CITY PLANNING COMMISSION

APPLICATION: A. Negative Declaration

- B. Special Permit to allow a drive-through window for an existing restaurant
- C. Variance to locate the required back-out and maneuvering space off-site
- D. Lot Line Adjustment to merge two lots
- E. Development Agreement to pay fair-share mitigation cost identified in the Alhambra Corridor EIR (withdrawn by staff)

APPLC. NO. P87-379 MEETING DATE October 22, 1987 ITEM NO 16

SITE PLAN

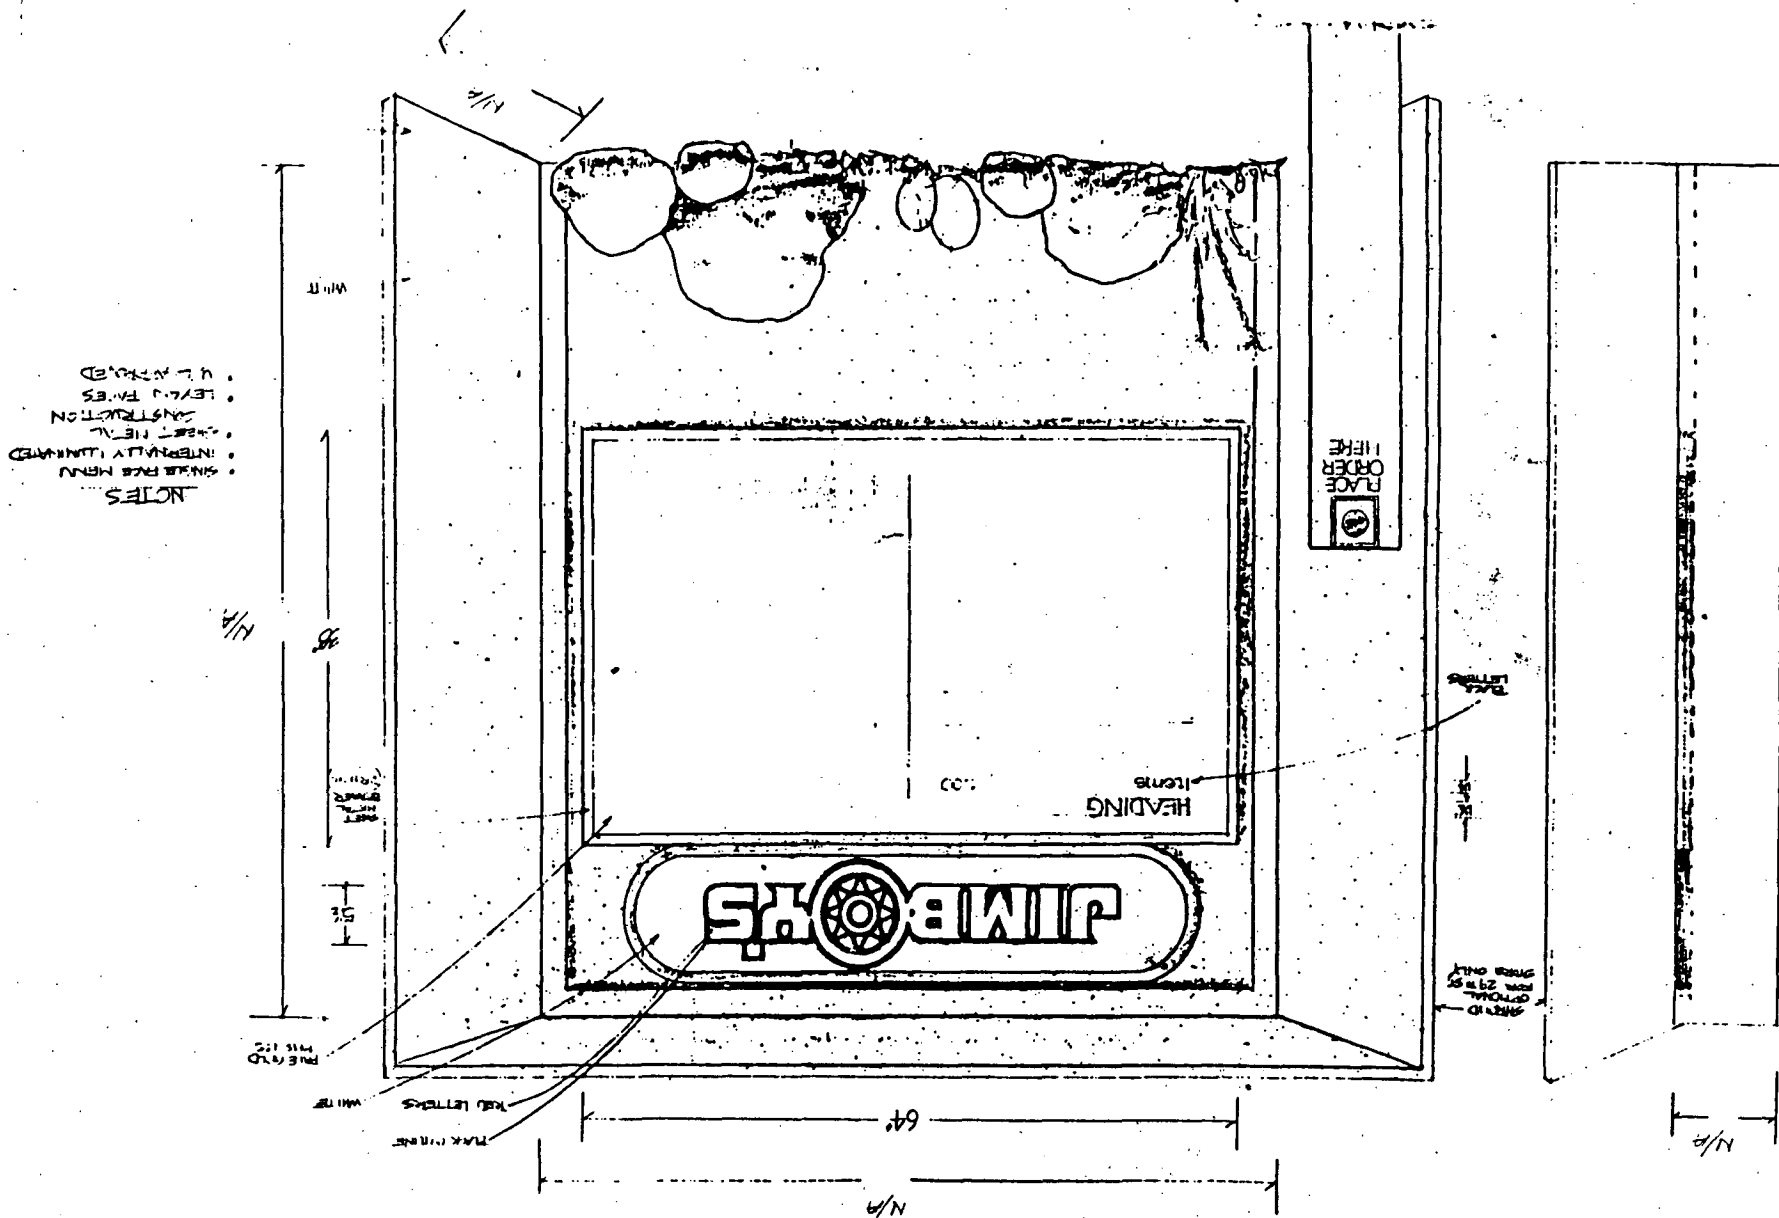
Delete this parking stall

3' high sound wall here.

6' high sound wall

RECOMMENDED LOCATION OF Speaker Box

PROPOSED 10' high sound wall

Proposed Speaker Box
